THE CITY OF KEY WEST

ADDENDUM #2

Electrical Enclosures & Fuel Station

Invitation to Bid: 13-011

1 ELECTRICAL OVERALL SITE PLAN
1" = 30'

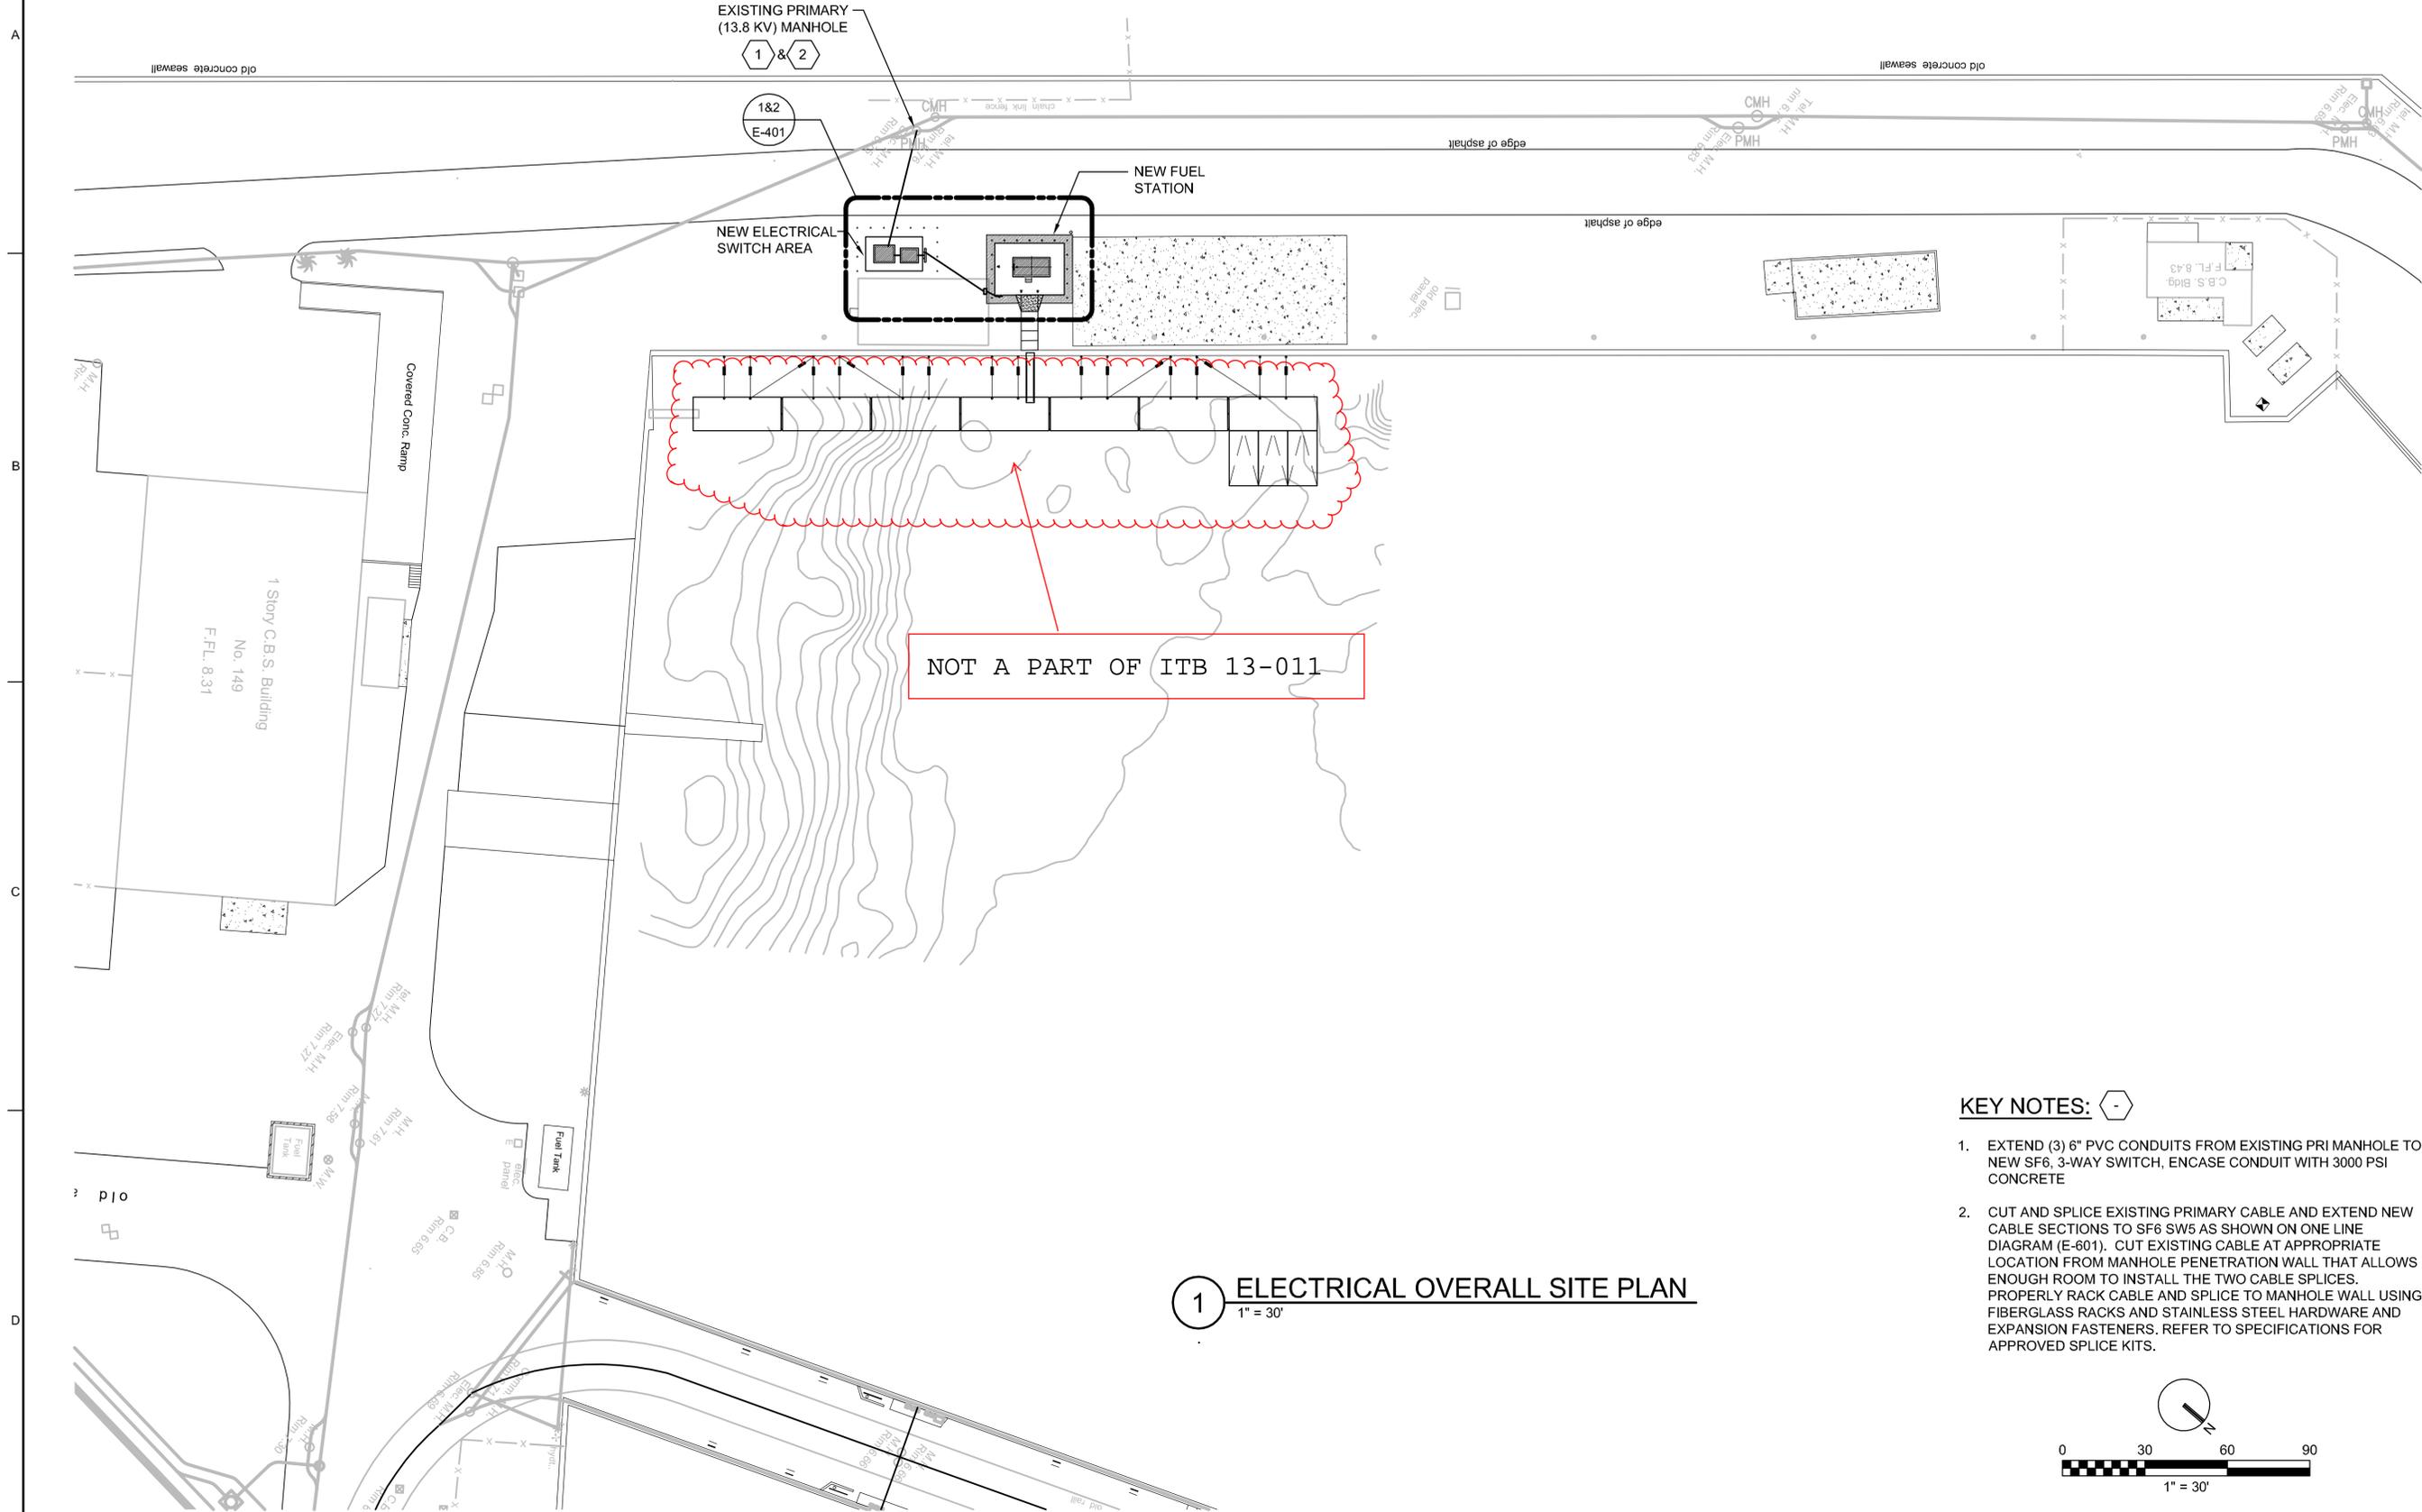
- b. Portions of Sheets S101 and E101 indicated are not a part of this project.
 - c. Any reference to “Floating Dock” and work associated with “Floating Dock” is not a part of this project.

NOT A PART OF ITB 13-011
